Project	IEEE 802.16 Broadband Wireless Access Working Group <http://ieee802.org/16>	
Title	Fast MSS-BS DL Data Flow Coordination for FBSS Support	
Date Submitted	2004-11-155-1-27	
Source(s)	Hang Zhang, Bill Gage, Shalini Periyalwar, Mo-Han Fong Nortel Networks	mhfong@nortelnetworks.com
	Mary Chion ZTE San Diego Inc	mchion@ztesandiego.com
	Itzik Shahar, Yigal Eliaspur Intel	Itzik.Shahar@intel.com
	Yong Seok Jin LGE	jayjay@lge.com
	Min-Sung Kim KT	cyberk@kt.co.kr
Re:	IEEE P802.16e/D5a-2004	
Abstract	A fast signaling mechanism is introduced to identify the next information unit to be transmitted by a new anchor BS while the MSS is in FBSS handoff. This is a revised contribution. Changes are highlighted in blue.	
Purpose	Review and Adopt the suggested changes into P802.16e/D5a	
Notice	This document has been prepared to assist IEEE 802.16. It is offered as a basis for discussion and is not binding on the contributing individual(s) or organization(s). The material in this document is subject to change in form and content after further study. The contributor(s) reserve(s) the right to add, amend or withdraw material contained herein.

Figure 20e4: SN Report Header Format

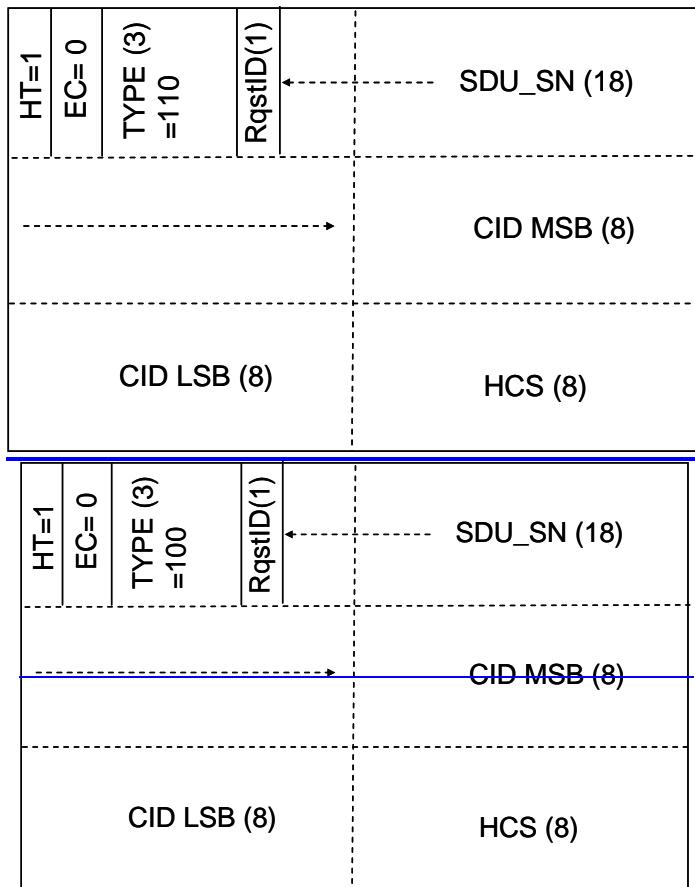
[Add a new section 6.3.2.1.86]

6.3.2.1.86 SN Report Header

The SN Report Header shall be of the form illustrated in Figure 1. The SN Report header shall have the following properties:

- The length of the header shall always be 6 bytes
- The EC field shall be set to 0, indicating no encryption
- The CID shall indicate the basic connection of the MSS for which the SN Report is being sent.

- The SDU SN field shall indicate the LSB of the next ARQ BSN or the virtual MAC SDU Sequence number for the active connections with SDU-SNSN Feedback enabled. The LSB of the ARQ BSN or virtual MAC SDU sequence number for each connection is provided. At most 3-three SNs can be provided in each SN Report Header in numerical ascending order of the CID values of the connections with sequence number feedback SDU-SNSN Feedback enabled.

- The RqstID field may be used to indicate whether the SN Report header is the first or second last subheader, thus - of two consecutive SN Report headers, to accommodate up to 6 active connections. The fields of the SN Report header are defined in Table 1. Every header is encoded, starting with the HT and EC fields. The coding of these fields is such that the first byte of a MAC header shall never have the value of 0xFF. This prevents false detection of the stuff byte.
